LAKEVIEW JSP18-16 with PRO Rezoning 18.723

LAKEVIEW JSP 18-16 AND ZONING MAP AMENDMENT 18.723

Public hearing at the request of Robertson Brothers Homes for Planning Commission's recommendation to City Council for a Planned Rezoning Overlay Concept Plan associated with a Zoning Map amendment, to rezone from R-4 (One Family Residential) and B-3 (General Business) to RM-2 (High-Density, Mid-Rise Multiple Family). The subject property is approximately 3.15 acres and is located south of 13 Mile Road on the east and west sides of Old Novi Road (Section 10 and 11). The applicant is proposing 21 single family homes and a storm water detention pond.

PLAN REVIEW CENTER REPORT

SHEET
 Rezoning Plan

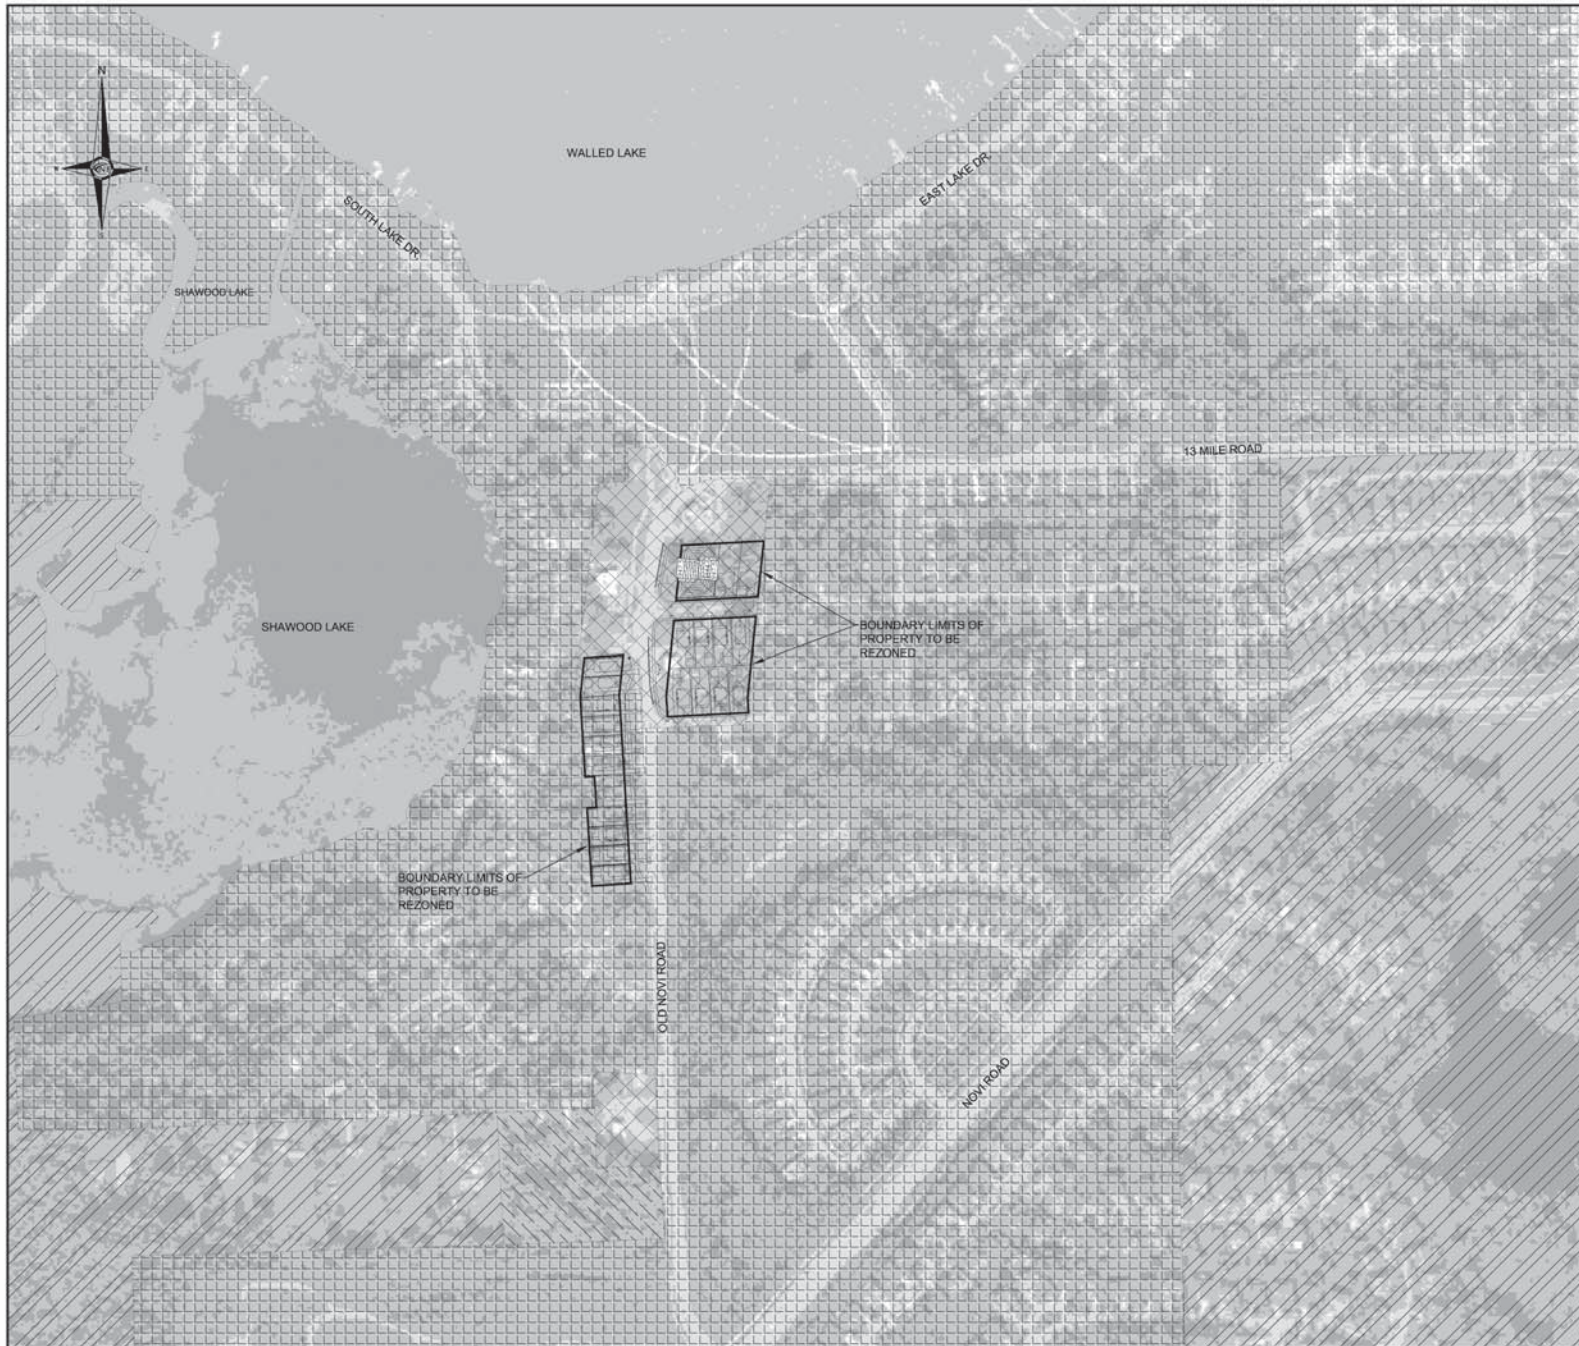
- c. Parcels 4 and 8 (SP8) contain existing homes and are not proposed to be rezoned to RM-2, but the lot dimensions will be altered by the platting of the proposed development. The rear setback of parcel 4 will be reduced and the lot area will be less than the 10,000 square feet required in the R-4 district. Parcel 8 will gain additional rear yard setback and area. Both of these parcels are labeled "Parcel D" on SP1. **The applicant is asked to clarify the intent for these parcels and identify any variances from Ordinance requirements that would be needed for their creation.**

Figure 1. City of Novi Regulated Wetland & Woodland Map (approximate project boundary shown in red). Regulated Woodland areas are shown in green and Regulated Wetland areas are shown in blue.

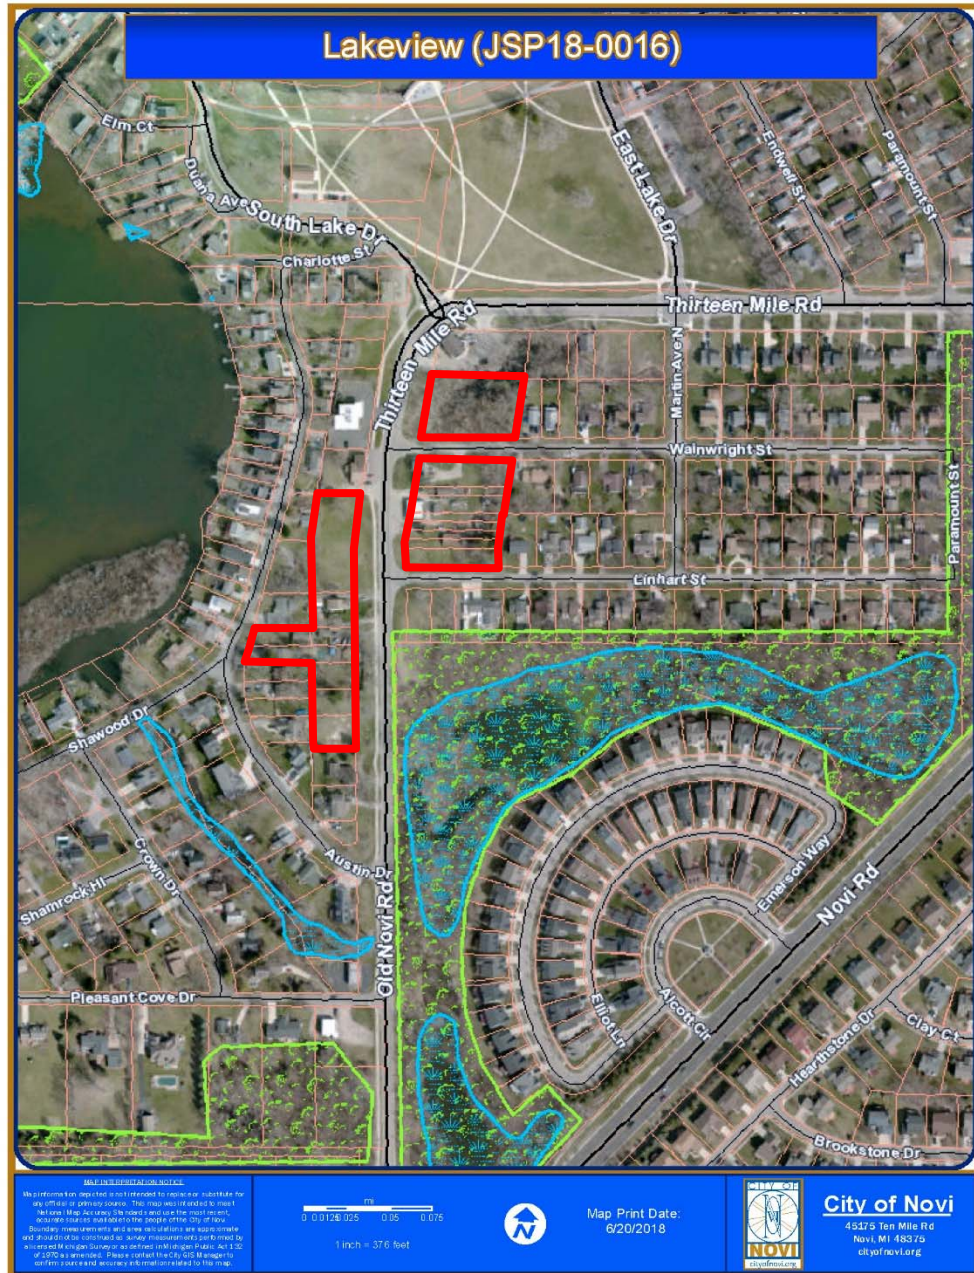
Based on our review of the Plan, Novi aerial photos, Novi GIS, the City of Novi Official Wetlands and Woodlands Maps (see Figure 1, attached) and our on-site evaluation, it appears as if the overall development site contains City-Regulated Wetlands. The BWA *Wetland Delineation and Determination of Jurisdiction* report dated October 3, 2017 notes that one (1) wetland area is present on the parcel and it has been determined that the wetland is subject to regulation by the Michigan Department of Environmental Quality (MDEQ) and the City of Novi. Permits will likely be required by the MDEQ and the City of Novi for construction activities involving this regulated wetland area. It should be noted that this existing wetland area is located on the subject parcel (Parcel C) located east of Old Novi Road and north of Wainwright Street (just south of the existing Lakeside Bar & Grill). This is the only wetland area observed on the proposed parcels being developed.

Although not indicated on the City of Novi's Regulated Wetland Map (see Figure 1), ECT identified one wetland area within the subject property at the time of the site inspection. This wetland was identified by BWA Consulting as Wetland B and wetland flag numbers are indicated as B-1 through B-14 (see Figure 2). The Plan notes that the on-site acreage of this wetland is 6,926 square feet (0.159-acre). The wetland area is an isolated forested/scrub-shrub wetland that contains an emergent depression. Vegetation observed within the wetland included silver maple (*Acer saccharinum*), cottonwood (*Populus deltoides*), box elder (*Acer negundo*), green ash (*Fraxinus pennsylvanica*), nodding beggar-ticks (*Bidens cernua*), and highbush cranberry (*Viburnum trilobum*). Surface water was present at the time of our inspection as well as water stained leaves which are an indicator of wetland hydrology. The applicant's wetland consultant noted that soils pits dug on-site revealed wetland (hydric) soils within the wetland area.

VARIANCE EXHIBIT

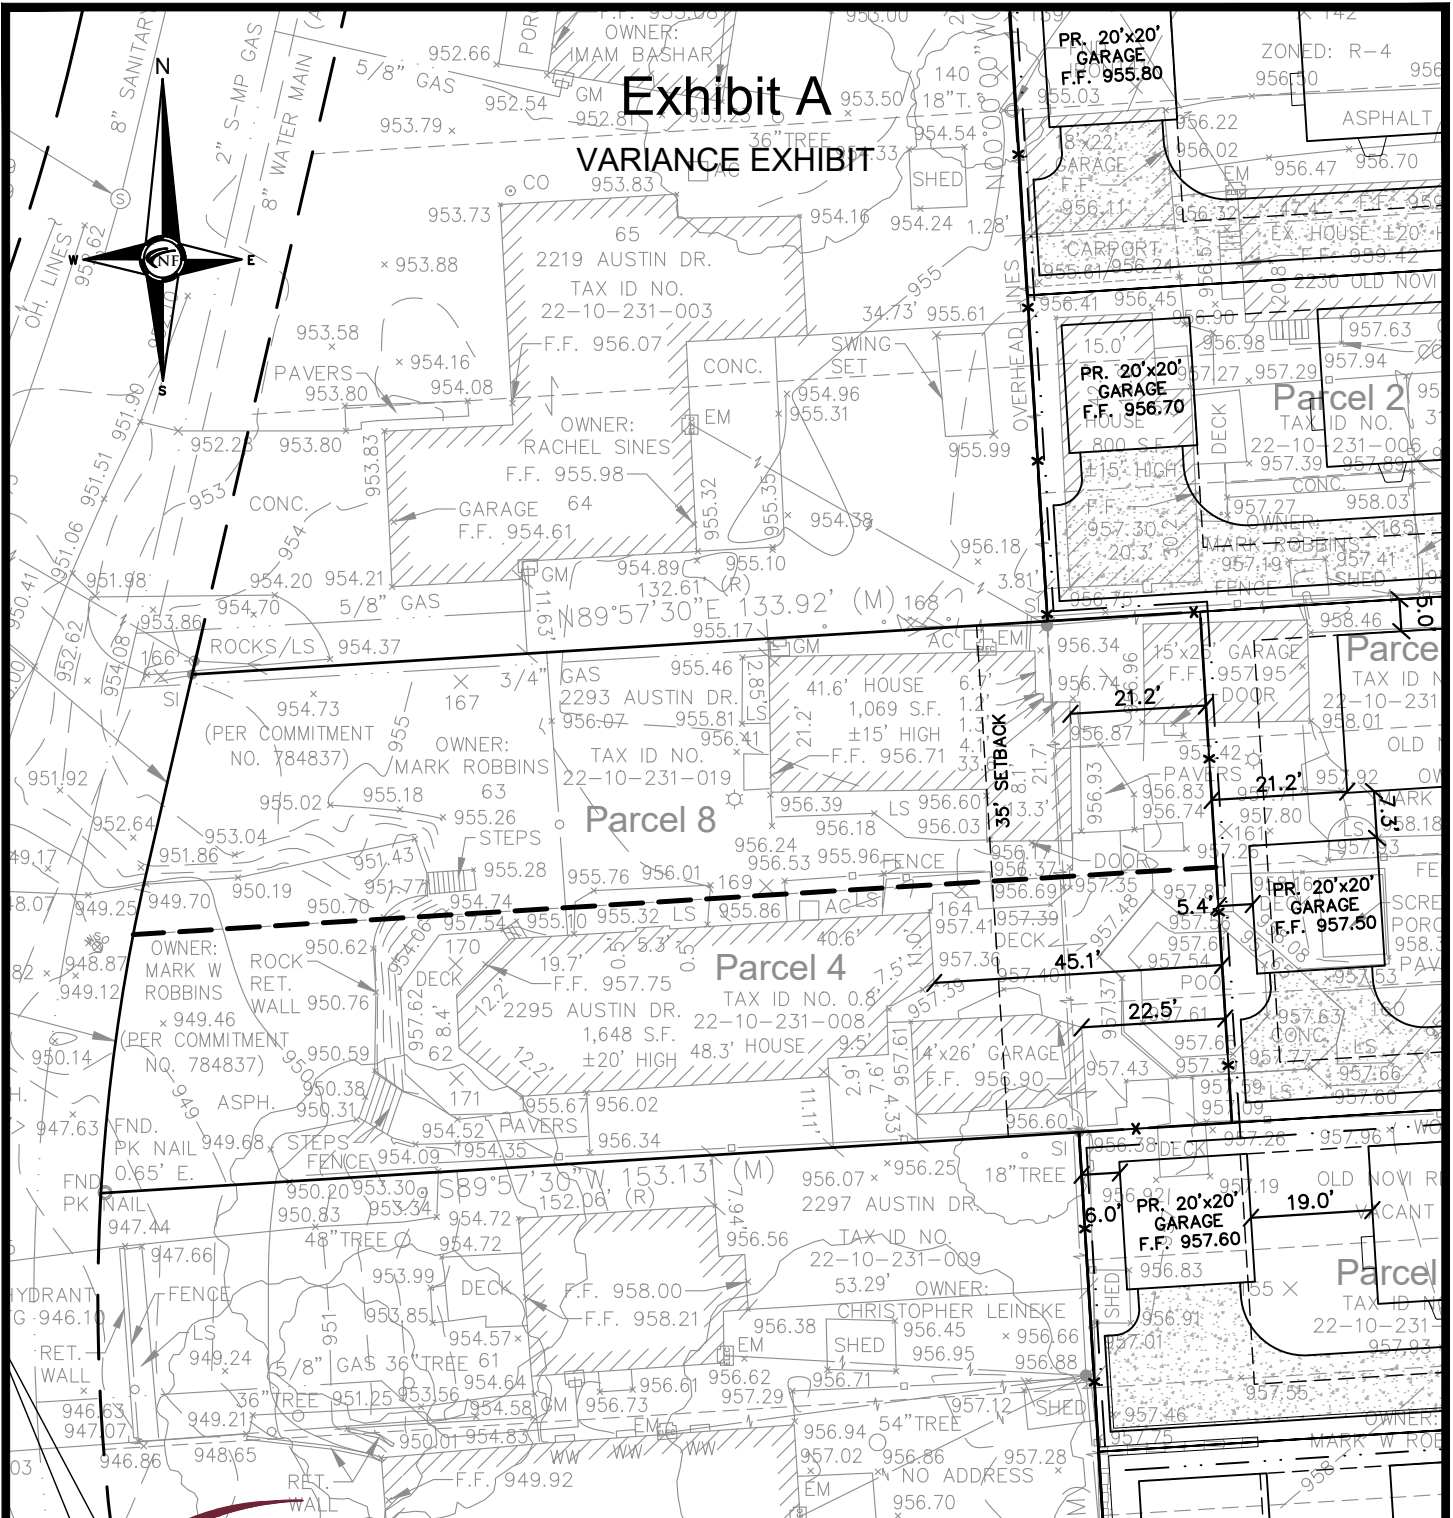
- j. Subdivision Ordinance deviation for site condominium unit boundaries extending into wetland area for lots 20 and 21; and
 - k. Planning deviations for lots 50-22-10-231-019 and 50-22-10-231-008 (remainder of lots fronting on Austin maintaining R-4 zoning designation) as follows:

- ii. Lot area of 6,500 square feet where 10,000 sf is required;
 - iii. Lot coverage of 30% where 25% is permitted.
2. If the City Council approves the rezoning, the Planning Commission recommends the following conditions be requirements of the Planned Rezoning Overlay Agreement:
